**STATE SIGNIFICANT DEVELOPMENT
ASSESSMENT REPORT:**

***Mixed Use Commercial, Retail and
Residential Development at 50 Honeysuckle
Drive, Newcastle***

SSD 8019

February 2018

Figure 8: Proposed built form with non-compliance with the 14 m and 24 m building height controls outlined in red and building heights for areas of the building in black (Source: Applicant's RtS)

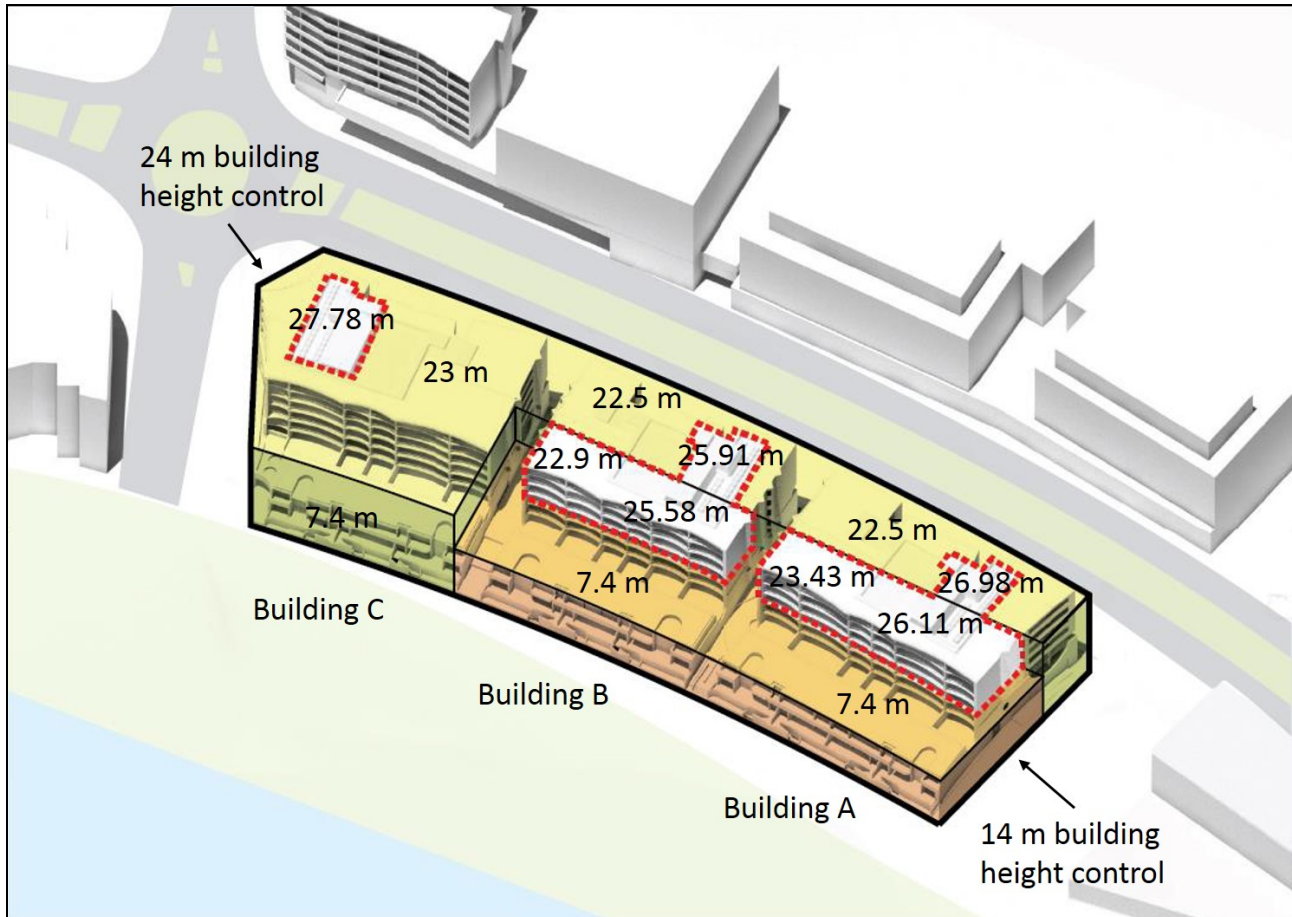
The Department has considered the two key areas of non compliance, being the:

- portions of Building A and B up to 26.11 m in the part of the site identified for a maximum height of 14 m
- the rooftop elements of Building A, B and C which exceed the control by between 1.91 and 3.78 m.

Figure 10: Proposed GFA and FSR (Source: Applicant's exception to development standard)

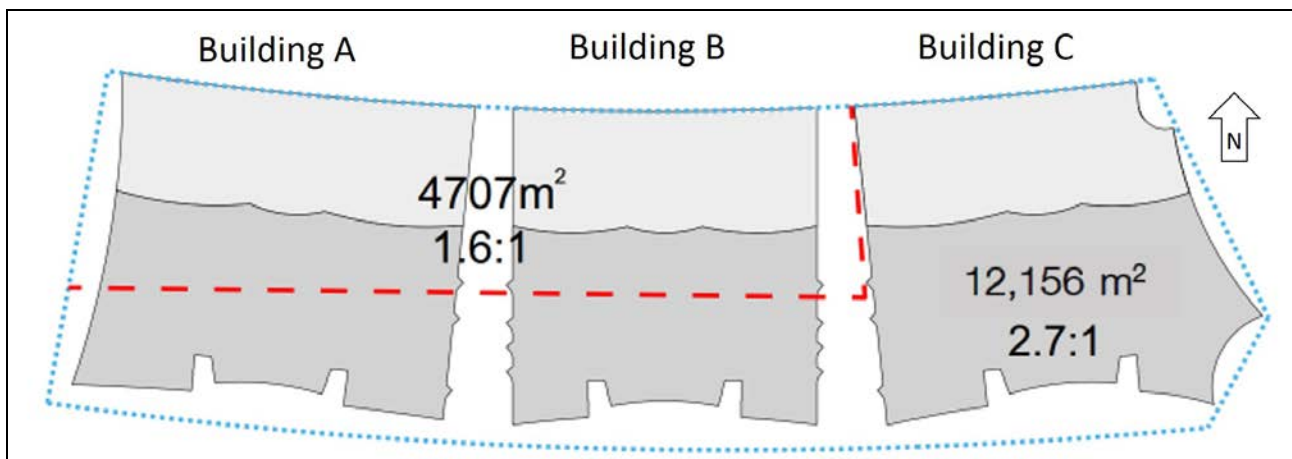
Overall this exceeds the maximum GFA permitted across the site by 43 m² (2%), however the Applicant is seeking to redistribute GFA across the site resulting in a variation to the 2.5:1 portion of the site, offset by a substantially lower floor space than would otherwise be allowed in the 2.0:1 portion of the site, as demonstrated in **Table 7** and **Figure 10**.

The Applicant has submitted a request under Clause 4.6 of NLEP to justify the proposed variation to of the floor space ratio development standard. The Department has considered this request (**Appendix D**) and is satisfied the proposal is consistent with the objectives of the development standard and zone, the proposed density provides a built form that responds to the existing and desired future character of the area and a high level of amenity for future residents. The recommendation to remove one communal rooftop area on Building C (as discussed in **Section 5.3.2**) will result in the combined site GFA reduced by approximately 12 m² and the combined site FSR variation to 1.8%.

Figure 12: Comparison of views from level 7 (uppermost level), 18 Honeysuckle Drive of an indicative compliant development and the proposed development with roof top communal areas. Rooftop communal area proposed to be removed by way of condition circled in red. (Source: Applicants RtS)

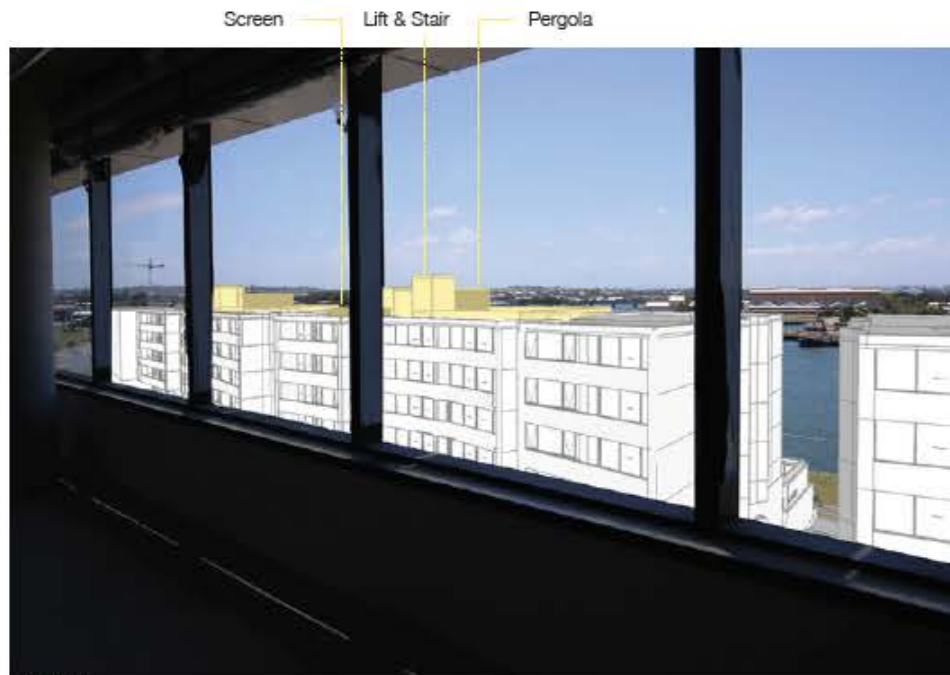
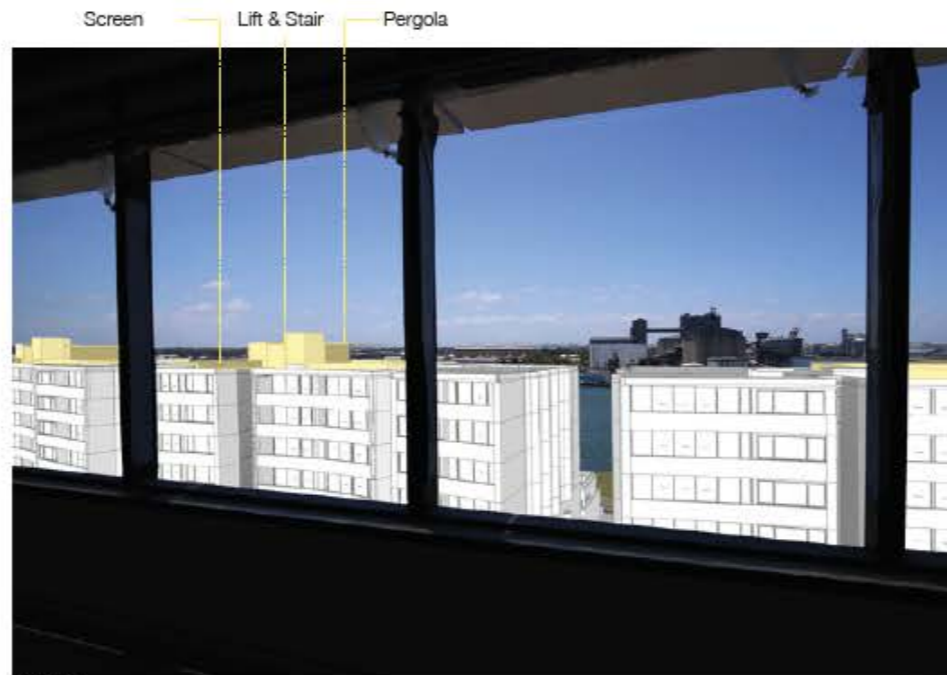
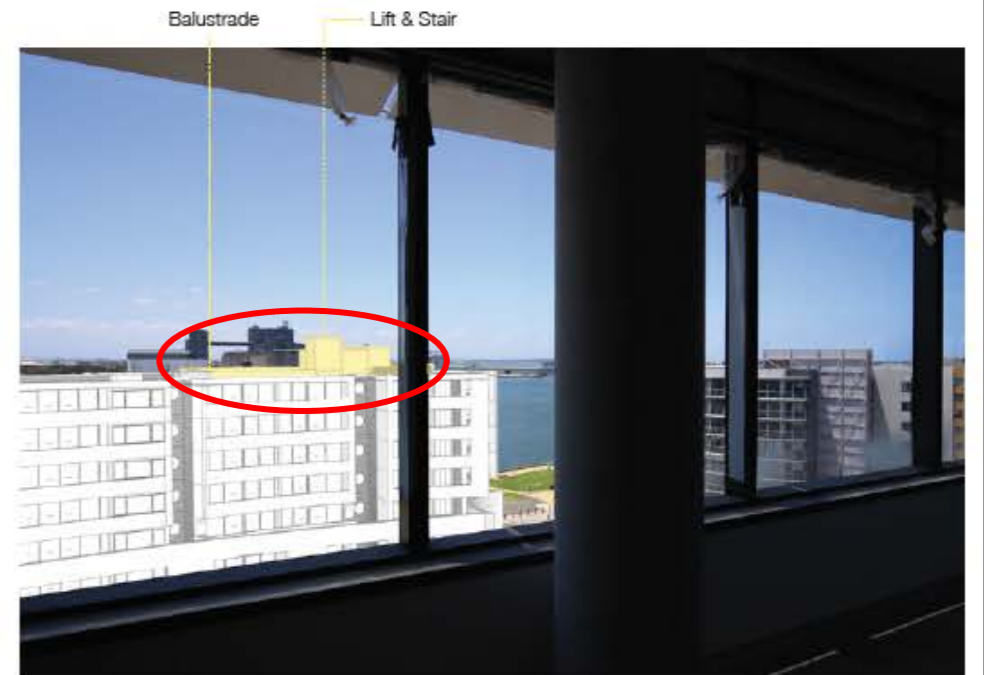
The proposed development will obstruct the views from level six and below. A view corridor remains between the through site link between Building B and C, and along the Worth Place view corridor, permitting some views of the Hunter River and foreshore (**Figure 12**). Level 7 of the building retains some view of land/ horizon interface over the proposed development. The view impact is considered severe.

The Department has considered this request (**Appendix C**). While the Department supports the additional rooftop structures which provide access to valuable rooftop communal open space for future residents, the Department notes (as discussed in **Section 5.4.2**) that any additional height above the 24 m height limit has the potential to further impact views.

Figure 14: Level 1 floor plan showing building separation distances (in black) and window / balcony placement and orientation (blue arrows) (Source: Applicant's architectural plans)

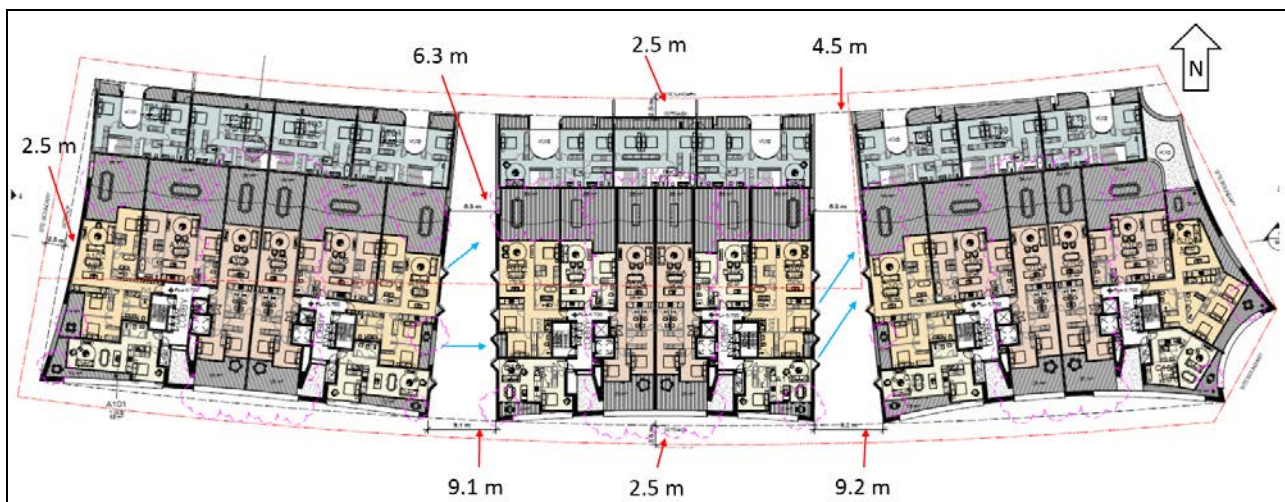
However, the proposal does not provide the 6 to 9 m setback which would be required to provide a total of 12 to 18 m between the site and the future mixed-use development on the neighbouring site to the west (35 Honeysuckle Drive). Notwithstanding, the Department considers the open space between the site and 35 Honeysuckle Drive is adequate for appropriate separation distances to be provided and the Department is satisfied the location of balconies and windows in the western elevation of Building A can achieve adequate levels of privacy despite the future redevelopment of this vacant site.

In addition, the internal separation between Buildings A, B and C (varying between 4.5m to 9.2 m) does not meet the recommended separation of 9 to 18 m outlined in the ADG (**Figure 14**).

However, the Department notes the habitable windows in the eastern and western elevations facing the through site links, from ground to level six, are orientated to the north and screens provided to prevent undue overlooking between habitable rooms and balconies (**Figure 15**). For the two storey terraces fronting the foreshore, windows openings to the through site links have been limited and where provided are lowlight/ highlight and offset to achieve privacy. The building separation increases in distance as the building height increases.

Figure 17: Ground floor communal waste room (outlined in red) (Source: Waste management Plan)

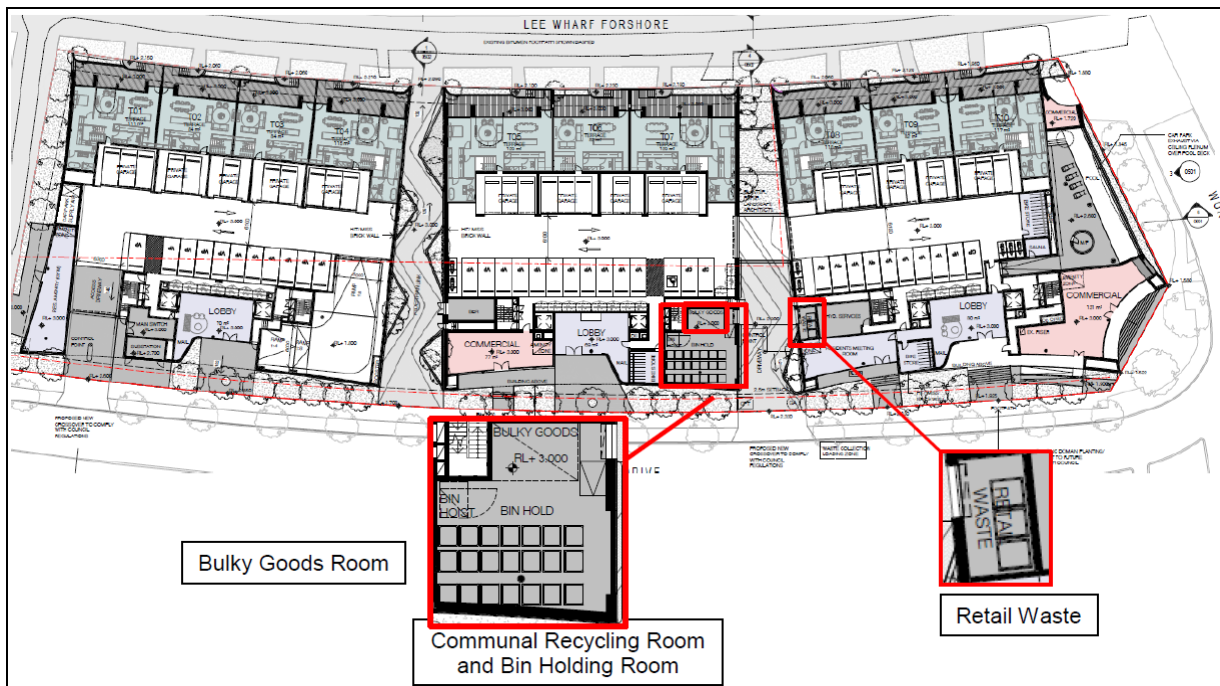
The Department notes the location of the waste room is not easily accessed for residents of both the terraces and apartments, will require residents to carry waste and recycling a considerable distance and through the public domain and is not safe. The Department is concerned that this will likely discourage recycling by future residents.

To address this and maximise access to useable recycling storage areas, the Department recommends a condition be imposed on the consent requiring the waste and recycling facilities be redesigned to provide:

Figure 18: Access arrangements (Source: Architectural plans)

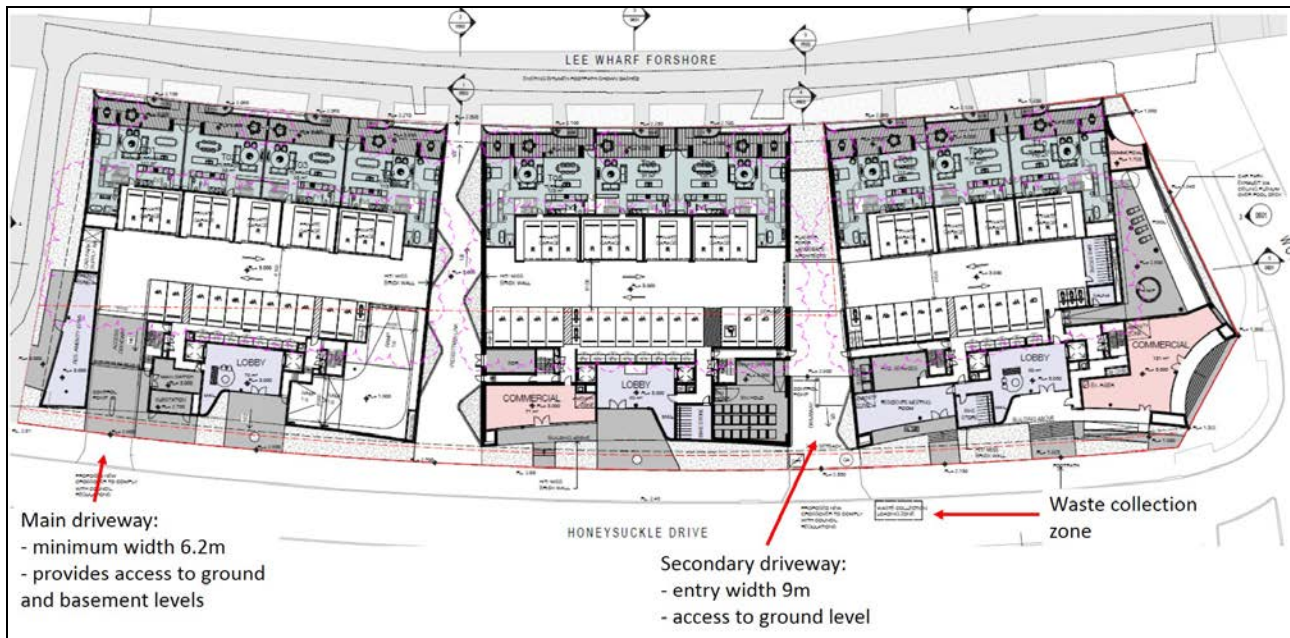
Council has also recommended that the width of the crossover at the eastern (secondary) driveway be reduced to a maximum of 6 m. The Department is satisfied the 6 m width will permit satisfactory access for vehicles entering and exiting the site without unduly impacting street parking and has recommended a condition accordingly.
